Reference No. 18-0064

This letter is in response to your March 21, 2018, email and subsequent conversations with a member of my staff requesting clarification of the Hazardous Materials Regulations (HMR; 49 CFR Parts 171-180) applicable to closure requirements for shipments of receptacles being transported by aircraft. Specifically, you ask if your client's bottle design as described below meets the requirements of § 173.27(d) for secondary closures.

**Ref.: Secondary closure seals**

<b>Abbott</b> A Promise for Life			
TITLE: <b>SNAP-ON BOTTLE ASSEMBLY, 1-L &amp; KEY-3 CAP</b>			
THRD ANGLE PROJECTION 	SIZE <b>B</b>	DWG NO. <b>Snap-On Btle Assy Key-3</b>	REV. <b>AC</b>
SCALE 1:2	DO NOT SCALE DRAWING	SHEET 1 OF 1

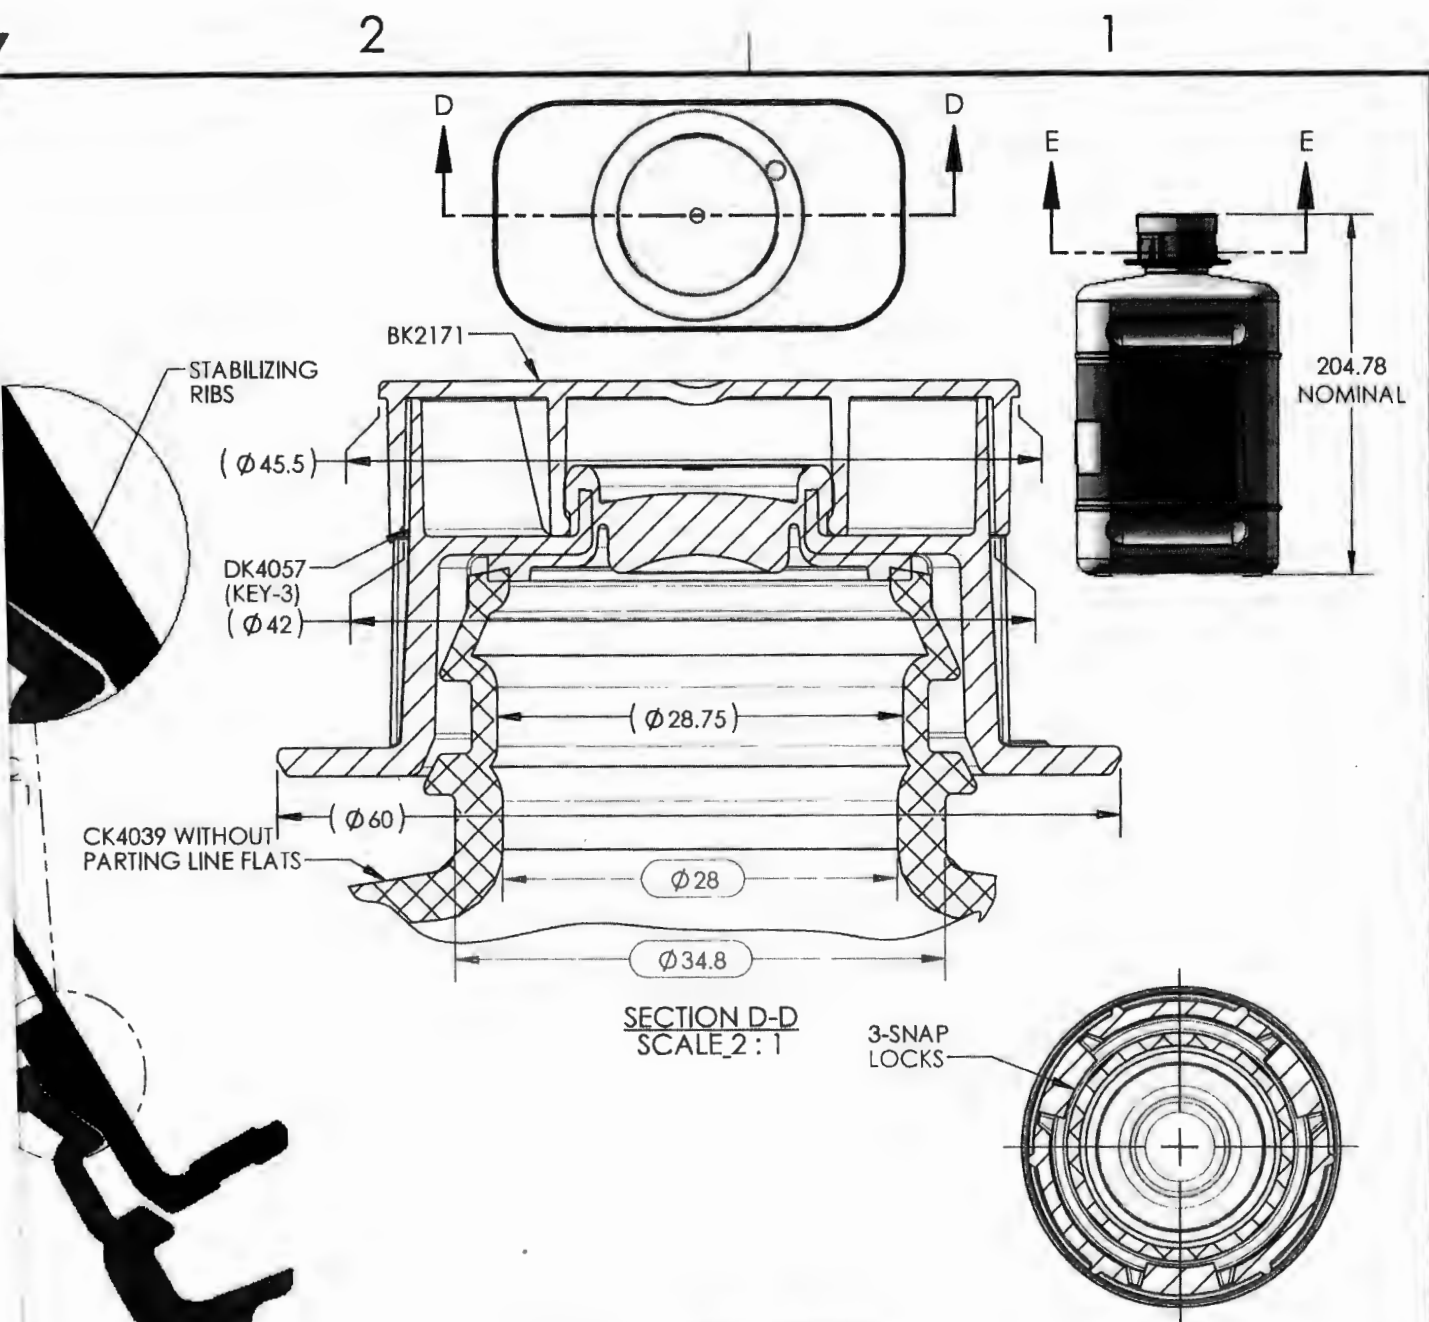
You provide technical drawings of your client's bottle design and further describe it as having a closure with an interlocking flange design that once connected to the bottle cannot be removed without destroying the closure or the bottle neck itself. You also state that the closure incorporates an "anti-back off" feature similar to a child lock.

I have been going over the drawing that you sent over with some others here and we just had one question for you that we couldn't quite tell from the drawings. We were wondering of the bottle is sealed with something over the top of it before the cap is placed or is the cap the only method used to seal the bottle. Let me know.

The cap has a flowed-in liner that engages the land area of the bottle to form a liquid tight seal. There is an additional friction-fit cap that sits over the septum area of the cap that forms a secondary seal to the septum itself but not the land area. Hopefully I am not confusing this situation for you.

After reviewing the description and technical drawings you provided, it is the opinion of this Office that the closure meets the closure requirements of § 173.27(d).
